Proposal & Rationale

The proposed amendments to the consented have been listed below as the and annotated on the proposed drawings submitted with this application.

Basement Floor Plan

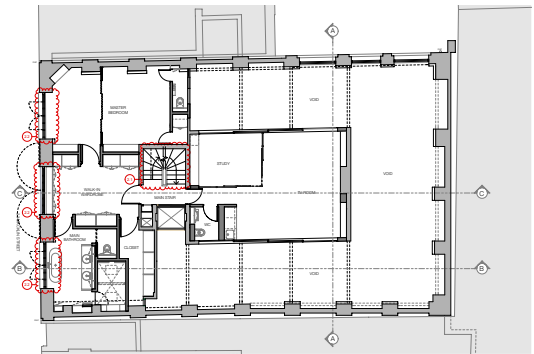
B.1 - Consented AV room and Riser arrangement to remain as existing. Window into Storage/Cellar to be blocked.

B.2 - Existing pool windows to be blocked.

B.3 - Removal of wall to create an opening into the separate Flat and new partition in the Storage/Cellar.

Second Floor Plan

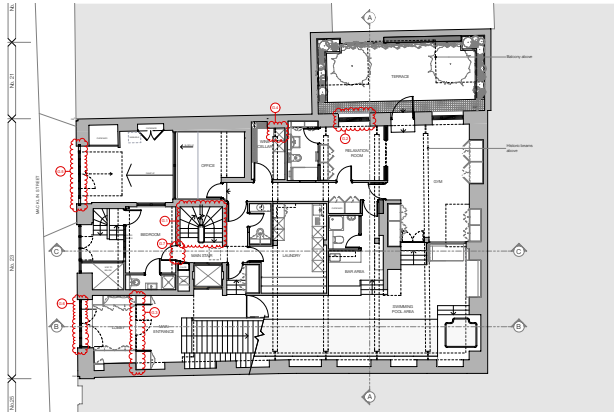
2.1 - Removal of modern main circulation stair and stair core, to be replaced with new timber stair with an open core.

2.2 - Windows to remain as consented but to move in plan to match position of existing.

Ground Floor Plan

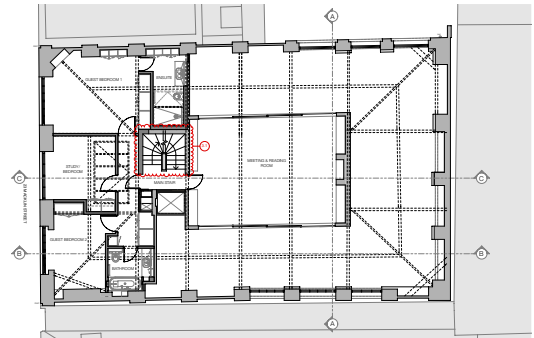
G.1 - Removal of modern main circulation stair and stair core, to be replaced with new timber stair with an open core.

G.2 - Consented new door into Courtyard to remain as existing window.

G.3 - Inner front door position and configuration different to consented.

G.4 - Consented removal of a section of original beam to remain as existing.

G.5 - Garage door frame to be rebated into the surrounding original brickwork, set in from the face of the render to align with window above. Frame arrangement/proportion amended to match frames of the windows above.

G.6 - Proposed main front door opening configuration amended. Frame arrangement/proportion amended to match frames of the windows above.

G.7 - Removal of wall to create an opening into the separate Flat from the main stair.

Third Floor Plan

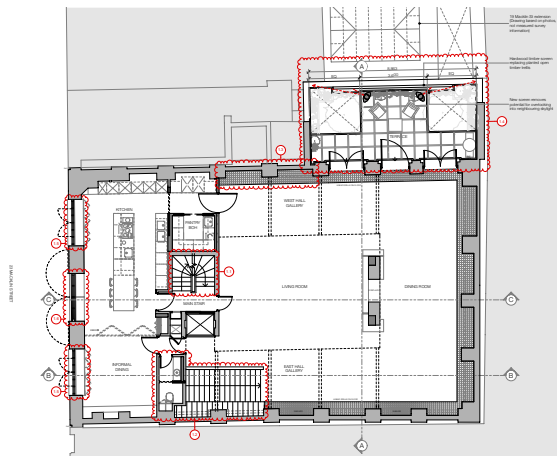
3.1 - Replace the consented removal of the main circulation stair with new, to align with below. Consented new stair up to Fourth Floor omitted.

First Floor Plan

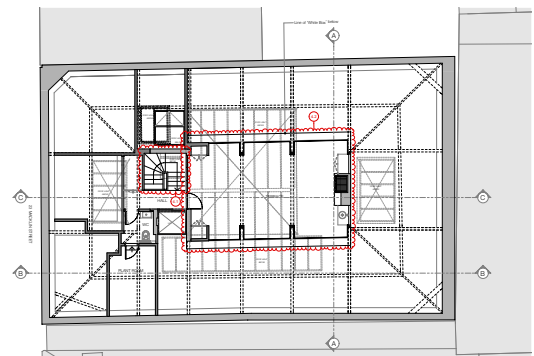
1.1 - Removal of modern main circulation stair and stair core, to be replaced with new timber stair with an open core.

1.2 - Entrance stair and WC configuration to remain as existing.

1.3 - Consented Stair up to the West Hall Gallery, which the required removal of a section of original beam (G.4), omitted. Consented grille denoting canvas slots extended.

1.4 - Proposed courtyard balcony to be increased in size, required privacy screen increased in size to suit.

1.5 - Proposed windows to match style of consented windows, moved in plan to match position of existing windows and cill lowered by 300 mm to better represent its historical proportions.

1.6 - Central bay window/door to remain as consented but to move in plan to match position of existing.

Fourth Floor Plan

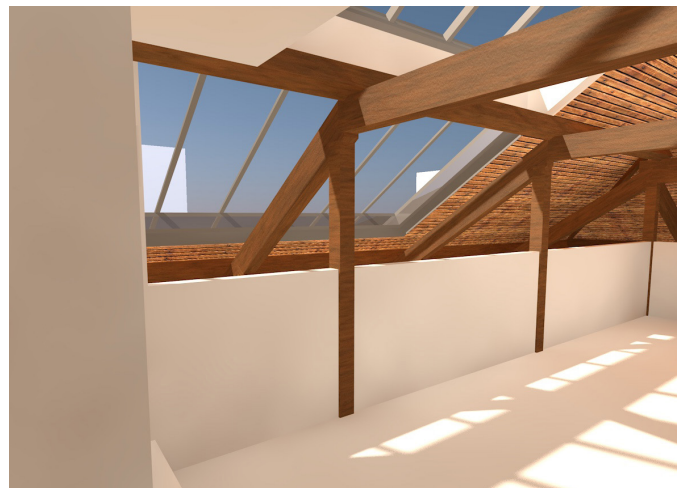
4.1 - New stair as per Third Floor note 3.1

4.2 - Widening the existing terrace and replacement of existing solid balustrades with glass balustrades. Each side is to widen but to be set back 400 mm from the edge of the 'white box' below.

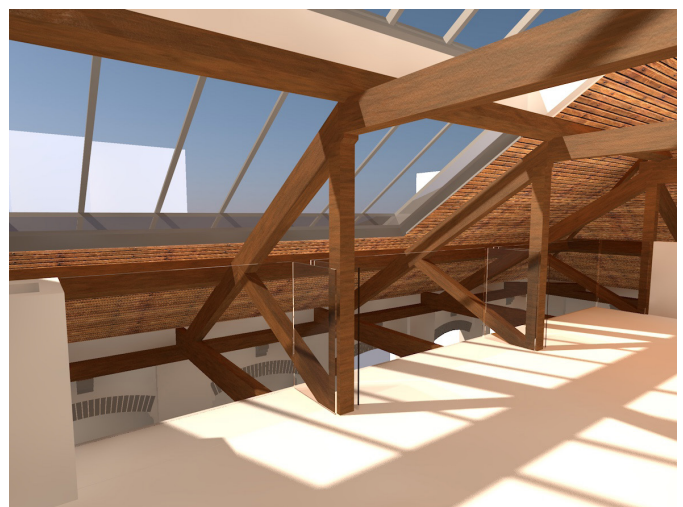
Existing vs. Proposed Fourth Floor Terrace visuals to indicate the little visual impact that widening the terrace will have from the First Floor and how the new glass balustrades allows one to better appreciate the historic roof trusses. (Please note that the bricks are shown as indicative white model, their treatment is consented and conditioned in Listed Building Consent 2014/0171/L).

Front Elevation

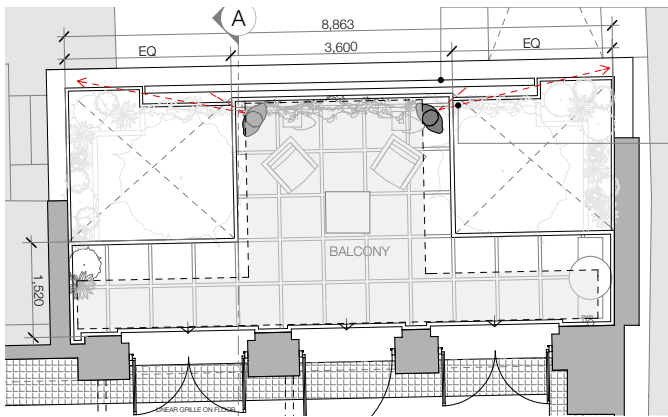
G.5 - Garage door frame to be rebated into the surrounding original brickwork, set in from the face of the render to align with window above. Frame arrangement/proportion amended to match frames of the windows above. *(Please note that the rebated frame will not change the visual size of the existing opening).*

G.6 - Proposed main front door opening configuration amended. Frame arrangement/proportion amended to match frames of the windows above.

1.5 - Proposed windows to match style of consented windows, moved in plan to match position of existing windows and cill lowered by 300 mm to better represent its historical proportions.

The proposal retains the consented window on the second floor as this better represents the historic. By lowering the cill of the First Floor window to match the size of the consented second floor, and better represent the size of the historic window, the proportions of the historic are restored.

On the Ground Floor, the style of the consented has been retained but the frame arrangement/proportion has been amended to match the windows above. Additionally to this, necessary dwelling elements have been added. These include letterbox and pedestrian door into the garage door.
